## ADDENDUM NO.3

### INVITATION FOR BIDS FOR CONSTRUCTION SERVICES FOR CAMARILLO STATION AMERICANS WITH DISABILITIES ACT (ADA) IMPROVEMENTS PROJECT

ISSUED June 8, 2026

SHEET  
**SP-02**  
22 OF 55 SHEETS

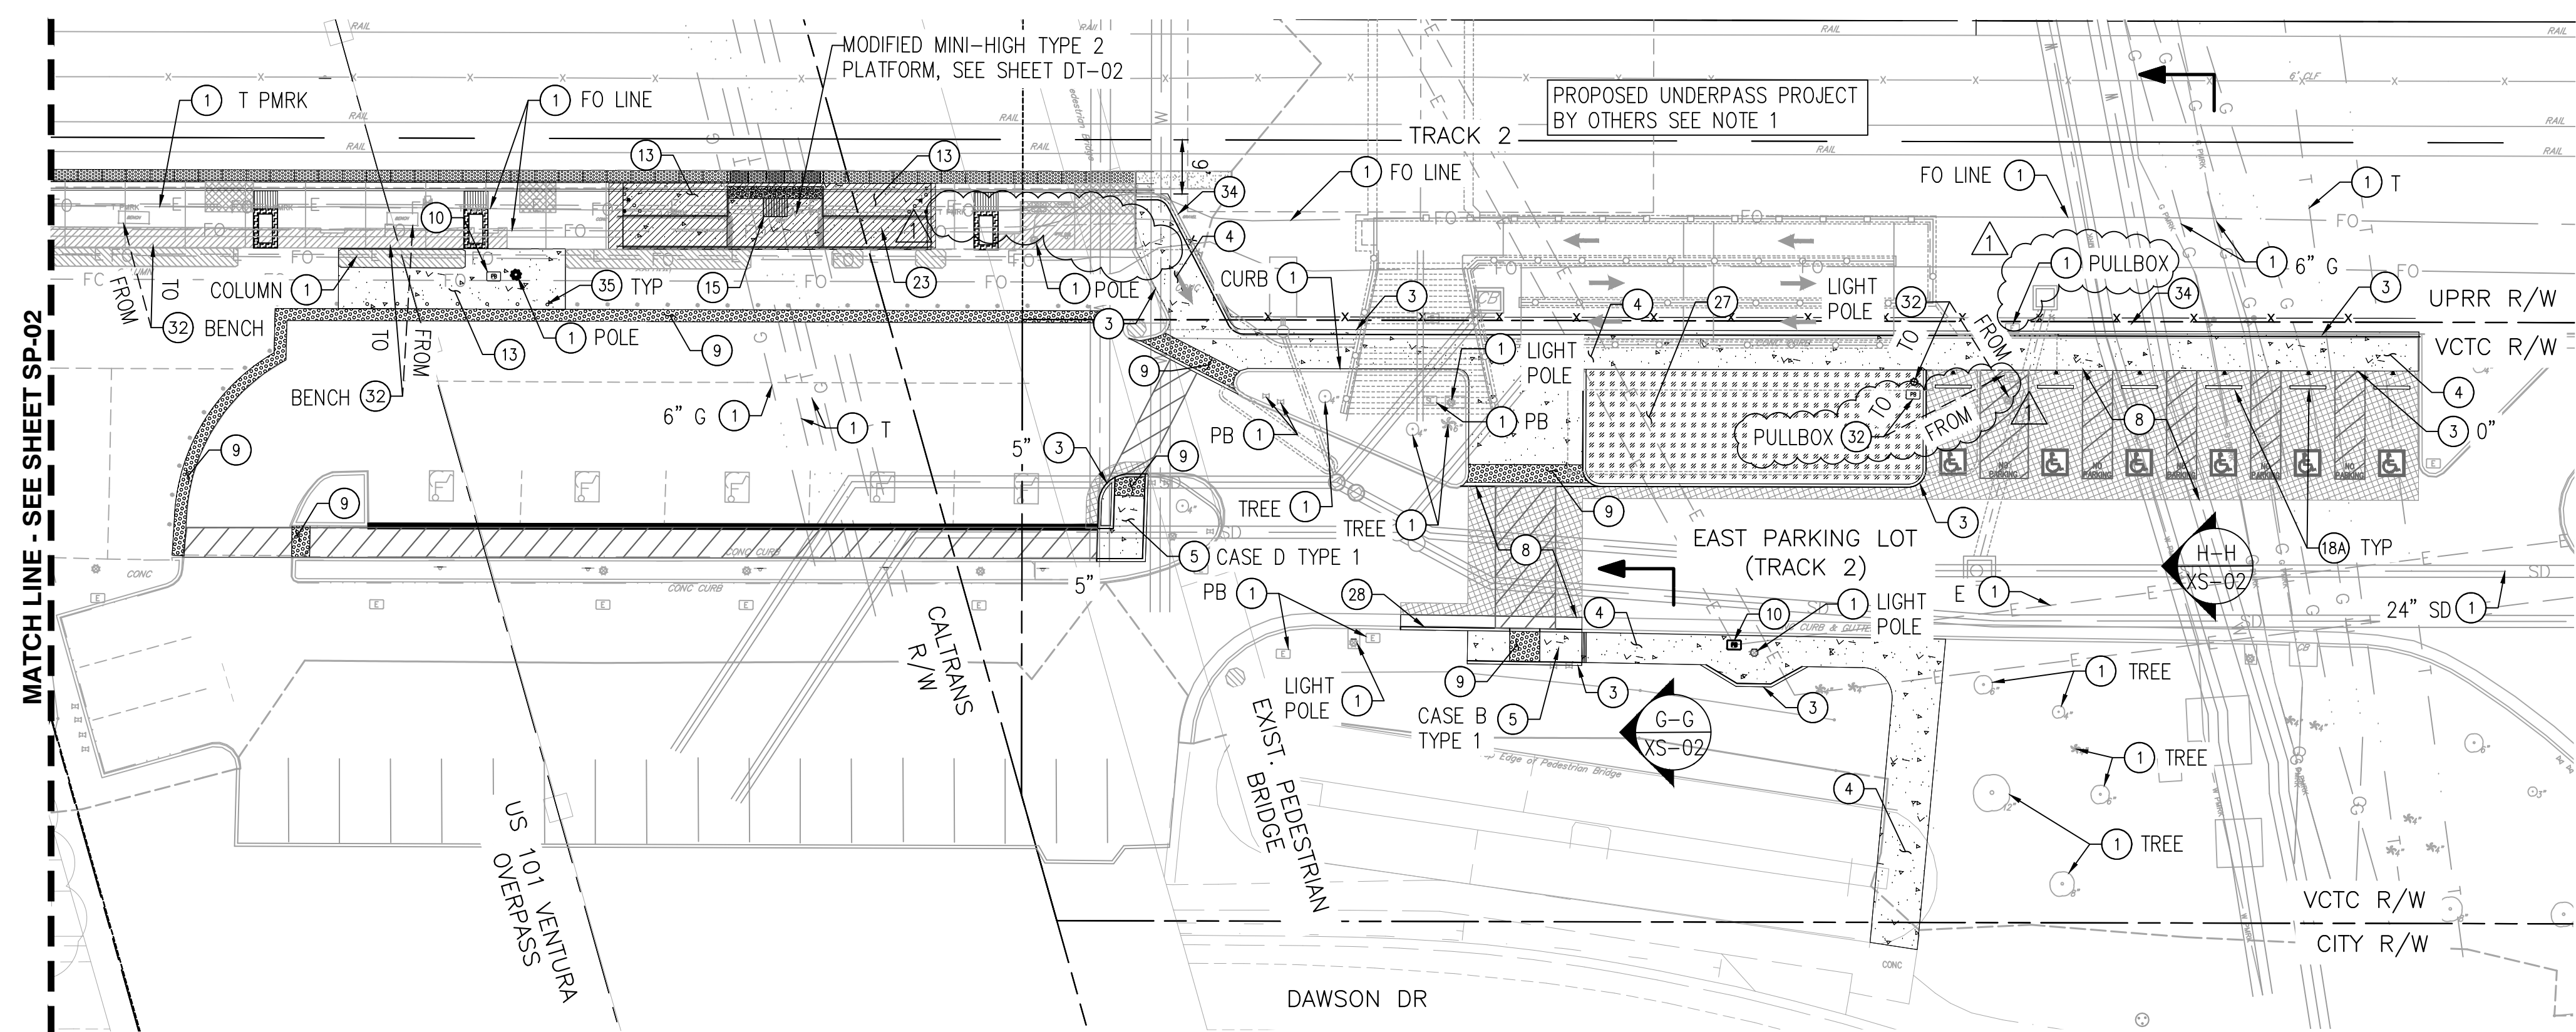
QUESTION:	Plan Sheet SP-02 calls to relocate Pedestrian Push Button and the pull box. Will the traffic signal conductors need to be replaced or is there enough slack in the pull box to accommodate the relocation of the existing pedestrian push button post and pull box at the Daily Dr Entrance (Bid Item #4.71)?
RESPONSE:	Pull boxes were not opened during design Phase. Contractor to assume conductors will be replaced in kind as needed.
